Dongguan Huien Electronic Technology Co., Ltd.

Ref: FCC Class II Permissive change for FCC ID: 2A2BY-056

This is to request a Class II Permissive change for FCC ID: 2A2BY-056 originally granted on 03/10/2025.

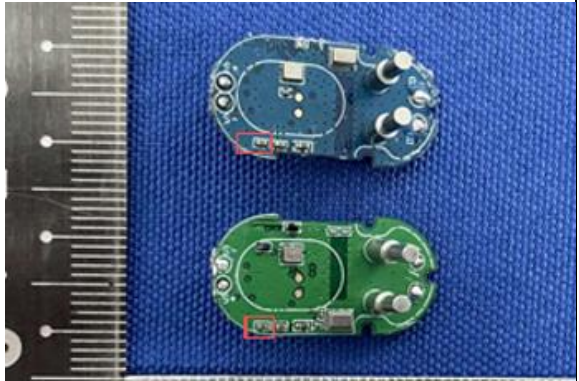
This application for modification is based on the original models HE-056A, ETO1, QX680, HE-056, FN-BT36, HE-056B, HE-056C, and HE-056D. The original accessory model QX680 is to be changed to QX68. The listed series models have different appearance colors and model names from the main model, but the circuit and electronic structure are the same. The model QX68 only has a change in the supplier of capacitor C21 on the baseboard.

Supplier	specification	Photos
Original	Dongguan Huien Electronic Technology Co., Ltd.	105/6.3V 0402 $\pm 10\%$	
New	Shenzhen Hanyang Antenna Design Co. Ltd.	105/6.3V 0402 $\pm 10\%$

The changes are not related with the other RF parameters, only "Conducted Emission and Radiation Spurious Emission of below 1G" were retested, other data were referred to the original report
